**Subject:** FBC comment

## Town of New Castle, New York: Chapter 60 Zoning

### § 60-860: Transect – Uses and Building Heights

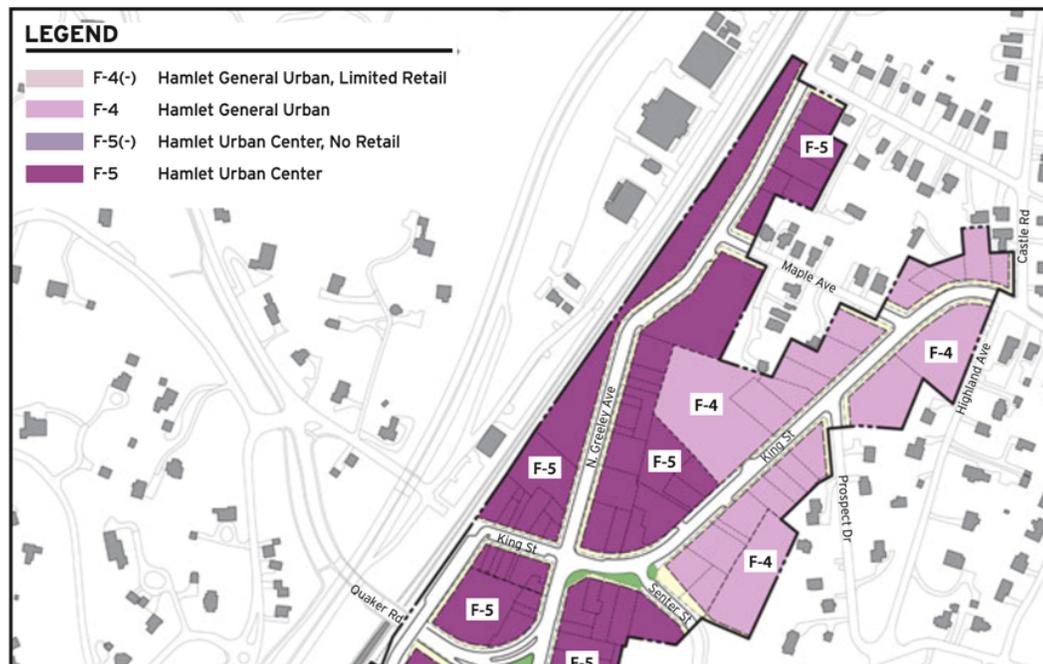
I'm not sure why the King Street hill corridor is included in the Form Based Code proposal, given that it is largely residential, or has the feeling of residential. I think the zoning change - IF ANY - should stop at Senter Street on the south side side, and at the little parking lot between what was the real estate agent (at 101 King) and the dentist (at 125) on the north side. At the other end, it seems reasonable to stop at Poillon on the south side, and at the Walgreen's lot on the north side - as it is currently drawn.

In other words, eliminate most or all of the pale pink F4 on the way up King. (I can't tell from your map where my demarkation point between 101 and 125 is - which is why I say all or most of.)

There is currently no sidewalk on the south side of King from a little below the intersection with Prospect, all the way up to Poillon. The FBC requires a sidewalk (or sidewalk with verge) of 10' to 20' wide. Therefore, logic says that there is no way to build under the FBC on much of the south side of King from because THERE IS NO WAY TO PUT IN A SIDEWALK due to the steep slopes. In my opinion, that's a stand alone reason to eliminate the south side pale pink F4 area. Why rezone to something that is simply impossible?
